TOYOTA TUNDRA

OUTLINE OF NEW FEATURES

The following changes are made for the 2010 model year.

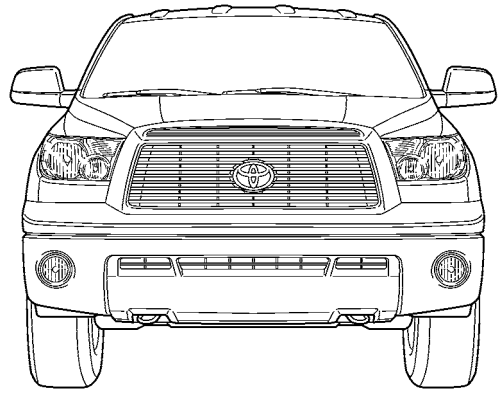
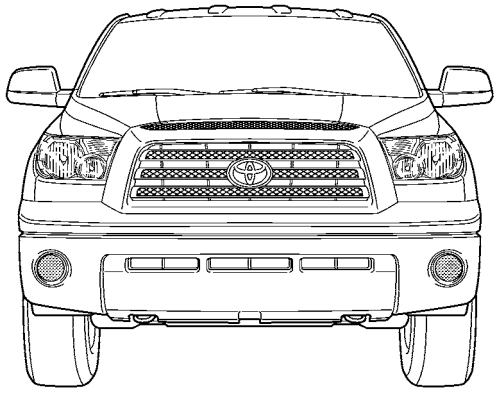
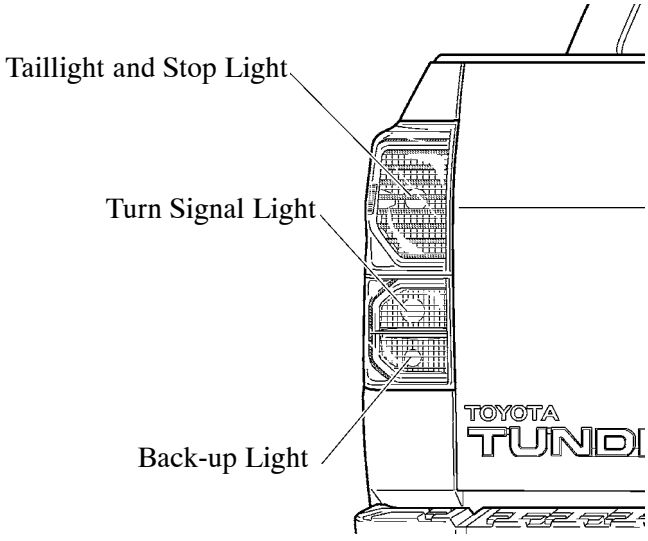
- The front design has been changed, achieving a wide and powerful look by emphasizing the width of the radiator grill and front valance panel.

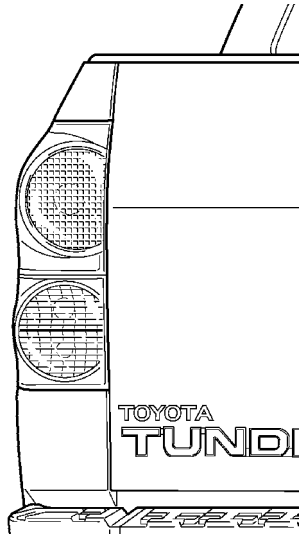
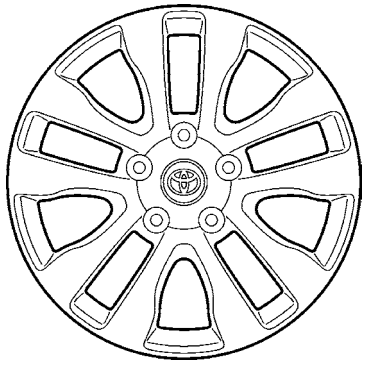
- The design of the rear combination lights has been changed, achieving a tough and serious image suitable for a full size truck.

Steering Wheel **Shift Knob** 12CMO002I

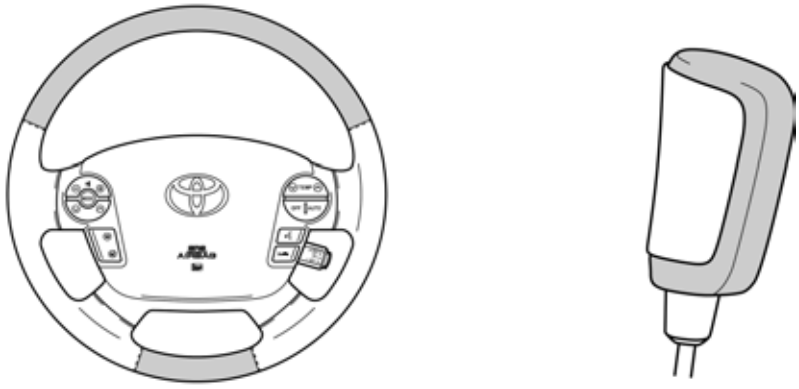
- A vinyl seat cover and vinyl floor covering are provided on the models with the work truck package.
- A perforated leather rear seat cover is provided on the platinum grade package.
- A woodgrain type door trim is provided on the limited grade.
- A woodgrain decoration has been applied to the steering wheel on the platinum grade package.
- A woodgrain decoration has been applied to the shift knob on the limited grade.

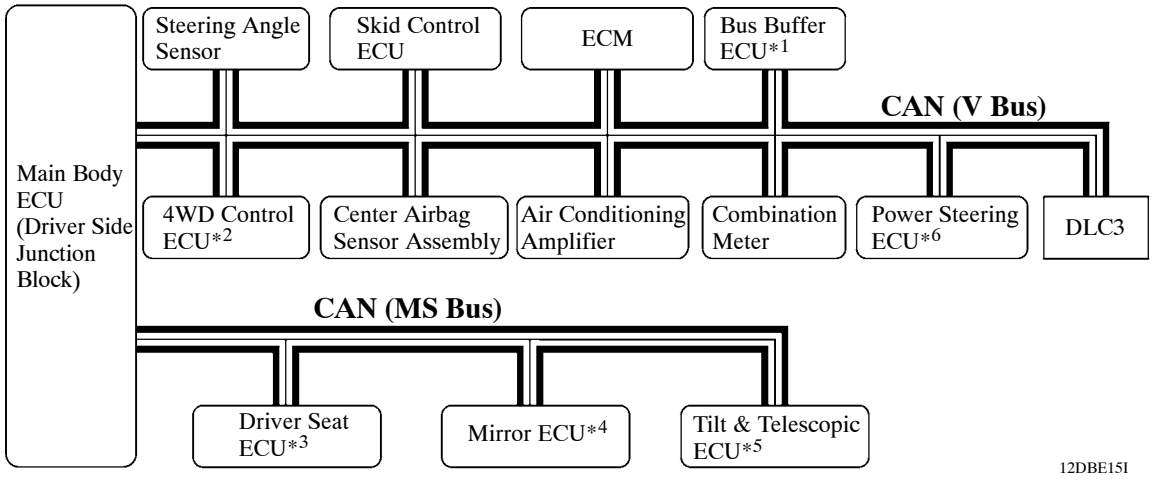
The construction of the Controller Area Network (CAN) has been changed due to the addition of the power steering ECU.

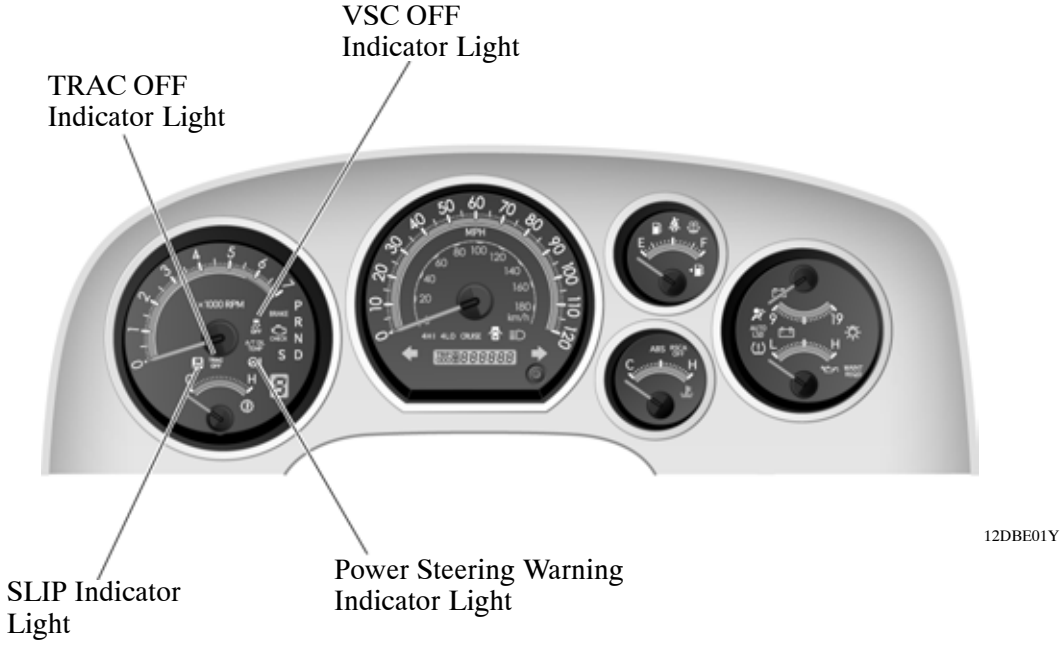
The 2010 Toyota Tundra has been modified from the 2009 Toyota Tundra, as shown below:

Item	2010 Toyota Tundra	2009 Toyota Tundra
TRAC OFF Indicator Light	 10SBE44Y	—
VSC OFF Indicator Light	 10SBE45Y	—
SLIP Indicator Light	 10SBE42Y	 10SBE47Y
Power Steering Warning Indicator Light*	 10SBE41Y	—
